Town of Farmington

PLANNING BOARD Wednesday, November 17, 2021 • 7:00 p.m.

MINUTES—APPROVED

Farmington Commons Plaza, November 17, 2021, photo #1.

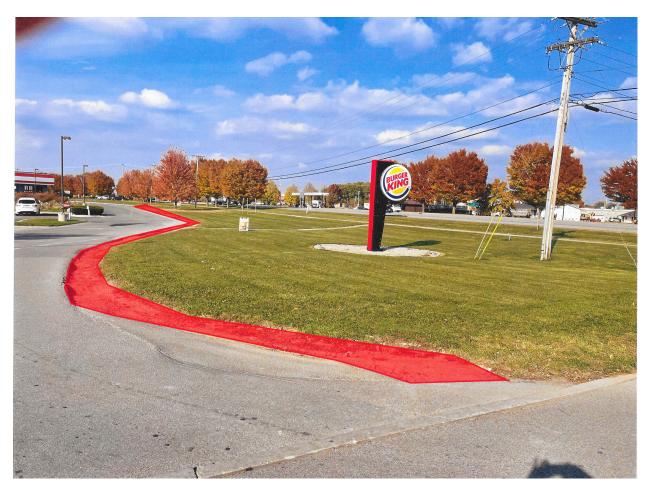
- 6. Finally, there is a dumpster at the end of the west end of the parking lot that is not ours, and we are not sure how it got there. We have asked Waste Management to remove by the end of the month or we will remove it and dispose of it on our own.

Mr. Stathopoulos wrote in a memo that the plan is to complete this work as quickly as possible, depending upon weather and availability of contractors. He said that he has submitted Requests For Proposals to contractors and that he will notify the Town when he receives firm dates.
